September 21, 1982

SBN - 329  
T.F. B7.1.2

Subject: Response to 440 Series RAIs; (Reactor Systems Branch)

FIGURE 3.4-4

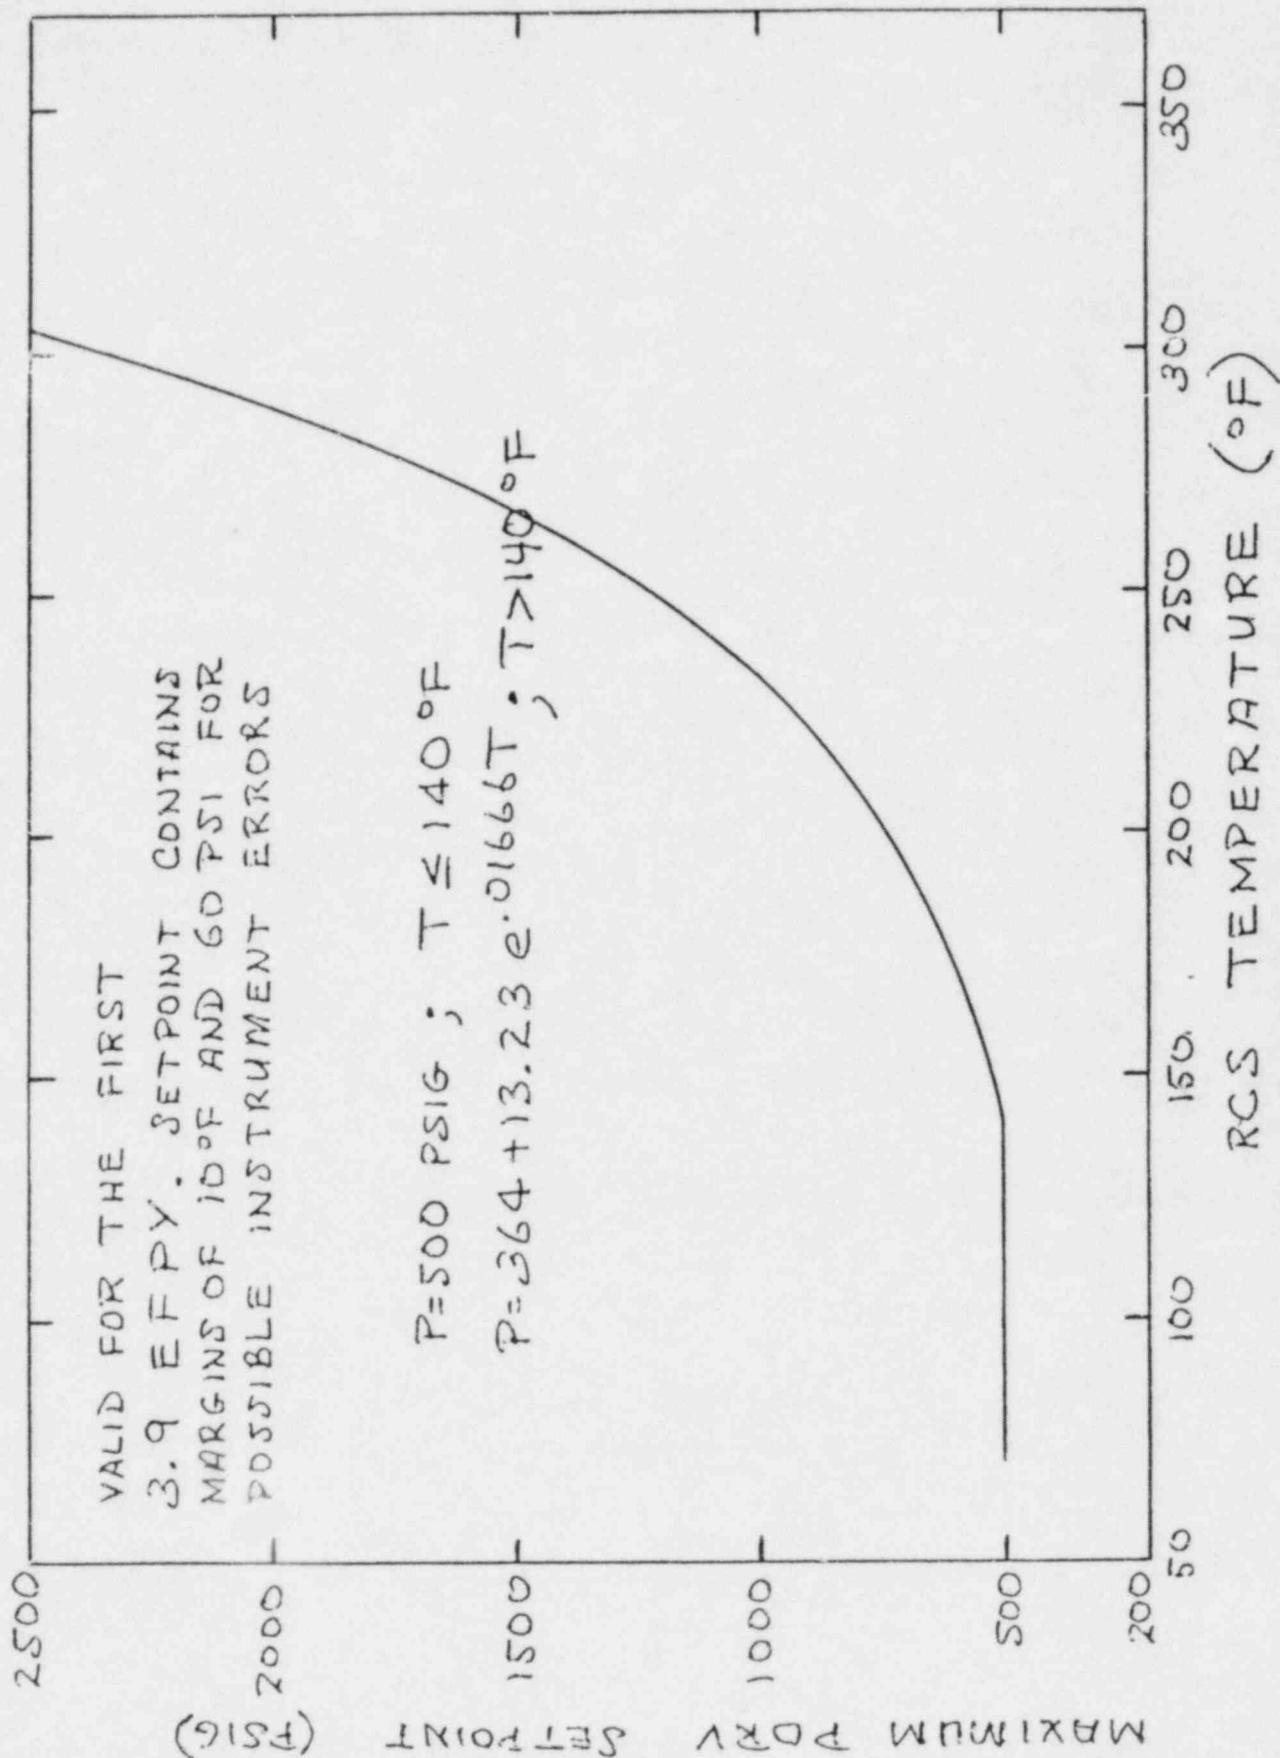
Per the requirements of BTP RSB 5-2, events that are excluded from the analysis, the controls to prevent these events should be included in the Tech. Specs. Address compliance with this requirement.

- a. Two power operated relief valves (PORVs) with a lift setting of less than or equal to ~~450 psig~~, or ~~the maximum setpoint defined by Figure 3.4-4~~, or <sup>later</sup>
- b. A reactor coolant system vent of greater than or equal to ( ) square inches.

APPLICABILITY: When the temperature of one or more of the RCS cold legs is less than or equal to <sup>305</sup>275°F, except when the reactor vessel head is removed.
